Enclosure

Discussion of Major Issues Associated With EPA's Compressed Waste Review

This attachment provides an expanded discussion of the major issues addressed in the correspondence from Frank Marcinowski to Paul Detwiler. The primary documents examined in the review of the compressed waste are the reports, *Effects of Supercompacted Waste and Heterogeneous Waste Emplacement on Repository Performance*, Revisions 1 and 2 by Hansen et al. (2003a and 2003b) and the *Determination of the Porosity Surfaces of the Disposal Room Containing Various Waste Inventories for WIPP PA* by Park and Hansen 2003b. These documents and others are in EPA's Docket A-98-49 or are contained as part of the 2004 Draft Compliance Recertification Application (CRA).

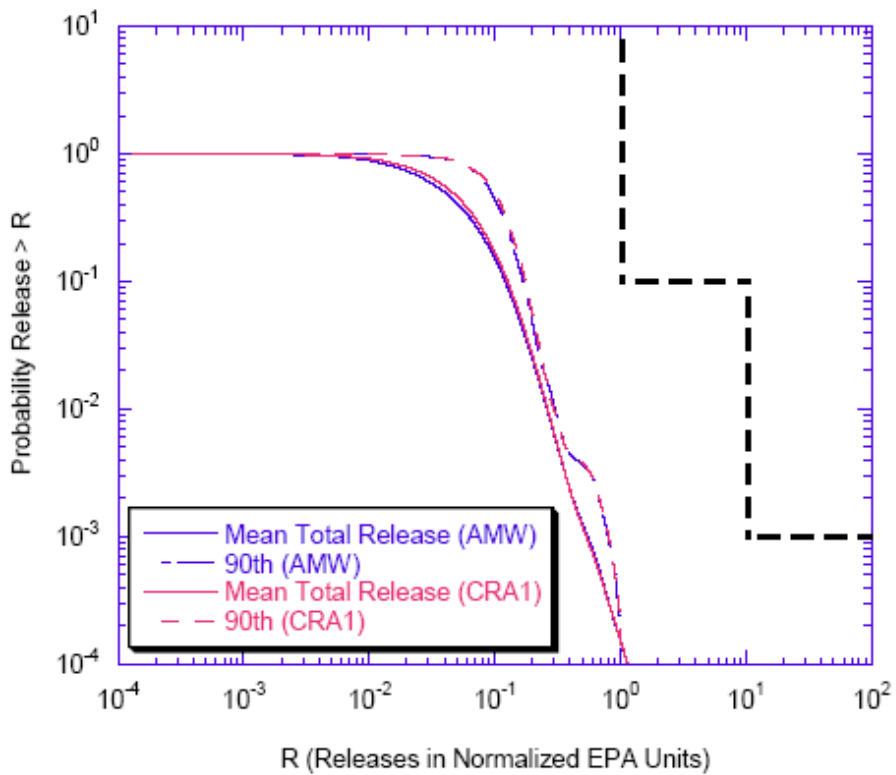
Since the AMW PA inventory and the 2004 CRA use the same inventory, DOE chose to compare the AMW PA with a modified CRA PA¹. In this comparison, the set of CCDF (cumulative complementary distribution function) curves for total normalized releases are almost indistinguishable. The mean total releases and the 90th quantile releases are almost identical. The porosity concerns EPA identified in the review and discussed below should not affect these results because additional analyses showed that important results are not affected by use of constant porosity or porosity surface. EPA's concerns related to the uncertainty are satisfied with a review of the means and 90th quantile of total releases presented in Table 1 and Figure 2.

However, the current regulatory baseline for PA is the PAVT conducted as part of the original certification decision process. As presented in Table 1 the AMW PA releases are lower than the PAVT at the 0.1 probability but higher at the 0.001 probability. While different from the PAVT, the higher releases at 0.001 are not due to AMW PA waste. Instead the differences appear to be due to an increase in cuttings and cavings releases. The cuttings and cavings releases appear higher because a few non-AMWTF waste streams with high radioactivity were sampled.
